1966 Corvette: Service Bulletin: Holley Carburetors - Primary Fuel Inlet Float Needle Sticking Closed

Subject: Primary Fuel Inlet Float Needle Sticking Closed - **Model and Year:** All Holley Carburetor Equipped Engines

Source: Chevrolet Technical Service Bulletin **Bulletin Number:** DR #66-38, Section VIm

Date: July 7, 1966

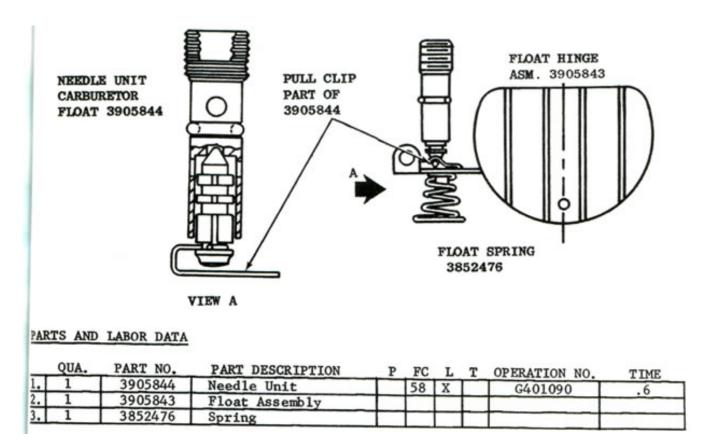
Stalling may occur on 327, 396 and 427 cu. in. engines equipped with Holley carburetor models 4160 or 4150 (except the Holley carburetor with center inlet on Corvettes). This may result from the primary fuel inlet float needle sticking in its seat after several hours "soak".

To prevent this condition, a new primary inlet needle was released for production March 28, 1966. The new needle has a clip (see sketch) which attaches to the float to assist in unseating the inlet needle. Carburetors have this production change may be identified by a date code stamped under the Chevrolet part number on the main body, i.e., "635" (6 - 1966; 3- March; 5 - 5th week) or later.

To take care of this problem in the field, the following parts were released for service June 27, 1966.

3905844 - Needle Unit - Carburetor Float

3905843 - Float Assembly

3852476 - Spring Carburetor Float

These parts should be installed as a set using the procedure outlined on page 2.
